適航指令發布單

民航局 AD 編號 AD number	CAA-2023-09-001	發布日期 Date issued	2023/9/5
適用之航空產品 Applied to (models, serial numbers or part numbers, as applicable)	This AD applies to all The Boeing Company Model 777-200, -200LR, -300, -300ER, and 777F series airplanes, certificated in any category, excluding the airplanes identified in paragraphs (c)(1) and (2) of this AD. (1) Boeing Model 777-200 series airplanes having a maximum taxi weight equal to or less than 547,000 pounds. (2) Boeing Model 777F series airplanes with manufacturer line numbers of 1743 and subsequent.		
主旨摘要 Subject	This AD retains the actions required by AD 2022-18-11(CAA-2022-09-012), and requires a maintenance records review of previously modified airplanes for the procedures used during that modification, and applicable corrective actions.		
民航局 CAA <input type="checkbox"/> 本國產品 Native product <input type="checkbox"/> 其他個案 Other	設計國民航主管機構 Original Authority <input checked="" type="checkbox"/> FAA <input type="checkbox"/> Germany LBA <input type="checkbox"/> EASA <input type="checkbox"/> CAA-NL <input type="checkbox"/> Brazil <input type="checkbox"/> UK CAA <input type="checkbox"/> Transport Canada Civil Aviation <input type=

Figure 1 to paragraph (h)(4) — Cap seal minimum thickness (all dimensions in inches)

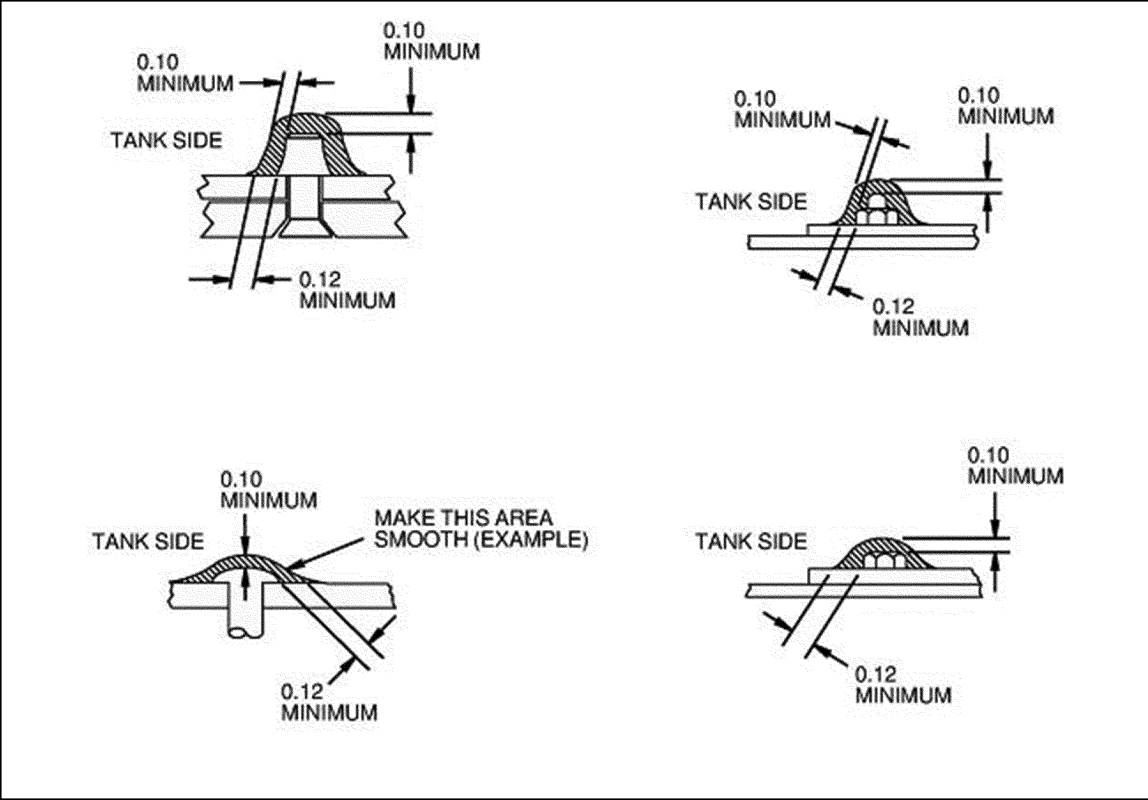
- (4) During application of any cap seal to a fastener, fastener head, and fastener threads and collars, as required by this AD, the cap seal must be applied with a thickness equal to or greater than the dimensions specified in figure 1 to paragraph (h)(4) of this AD.

(6) Where Boeing Alert Requirements Bulletin 777-57A0122 RB, dated October 8, 2021, requires inspections that may require the removal of fastener cap seals, this AD requires that if the cap seal is removed, a cap seal of BMS 5-45 sealant be reapplied with a thickness equal to or greater than the dimensions specified in figure 1 to paragraph (h)(4) of this AD before further flight after completion of the inspection.

(ii) All cap seals were applied using procedures with thickness dimensions greater than or equal to those given in figure 1 to paragraph (h)(4) of this AD.

(2) If any cap seal was applied using procedures with thickness dimensions less than those given in figure 1 to paragraph (h)(4) of this AD, or if the maintenance records do not definitively specify the procedures used: At the applicable time specified in paragraph (i)(2)(i) or (ii) of this AD, replace the cap seal in accordance with the Accomplishment Instructions of Boeing Alert Requirements Bulletin 777-57A0122 RB, dated October 8, 2021, using a cap sealing procedure with thickness greater than or equal to the dimensions given in figure 1 to paragraph (h)(4) of this AD.

(3) For any cap seal that was not applied, or for any cap seal that was removed for inspections and not replaced, or if the maintenance records do not definitively specify the procedures used: At the applicable time specified in paragraph (i)(3)(i) or (ii) of this AD, apply a cap seal of BMS 5-45 sealant using an accepted method with thickness greater than or equal to the dimensions given in figure 1 to paragraph (h)(4) of this AD.
